Access Compliance Report Public Rights-of-Way (Curb Ramps)

Main Street: CECIL_PASTURE_RD Cross Street: N/A Location: W

ADA ID: RPRK211026130638 Ramp Type: Type 4 - Parallel Initial Pass/Fail: Fail Overall Compliance: No Severity Score: 16

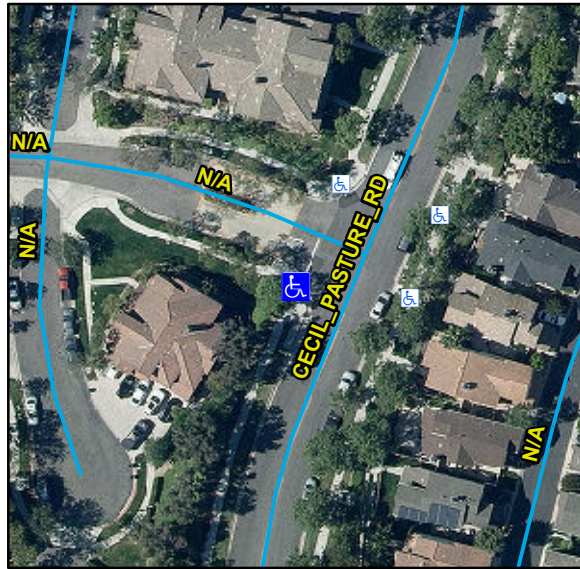
R204.3, R304.3.2, R304.5.3, STD 1115

Compliance	Description	Data	Compliance	Description	Data
N/A	Ramp Length LT (in)	104	N/A	Ramp Length RT (in)	110
Yes	Ramp Width LT (in)	90	Yes	Ramp Width RT (in)	90
No	Ramp Run Slope LT (%)	10.4	Yes	Ramp Run Slope RT (%)	0
No	Ramp Cross Slope LT (%)	2.8	No	Ramp Cross Slope RT (%)	2.3
N/A	Landing Present	N/A	N/A	DWS Provided	N/A
N/A	Landing Length (in)	N/A	N/A	DWS Contrast	N/A
N/A	Landing Width (in)	N/A	N/A	DWS Length (in)	N/A
N/A	Landing Run Slope (%)	N/A	N/A	DWS Full Width	N/A
N/A	Landing Cross Slope (%)	N/A		DWS Offset Type	N/A
N/A	Landing Movement Obstructed?	N/A	N/A	DWS Offset Left (in)	N/A
	Landing Movement Type	N/A	N/A	DWS Offset Right (in)	N/A
N/A	Landing Shared	N/A			
N/A	Clear Space	Yes			
N/A	Clear Space To Crosswalk (in)	N/A			
N/A	Marked Crosswalk 1	No	N/A	Marked Crosswalk 2	No
	Crossing 1 Direction	SE		Crossing 2 Direction	NE
	Marked Crosswalk 1 Width (in)	N/A		Marked Crosswalk 2 Width (in)	N/A

Remove & Replace Curb Ramp With Two New Directional Ramps or Equivalent.
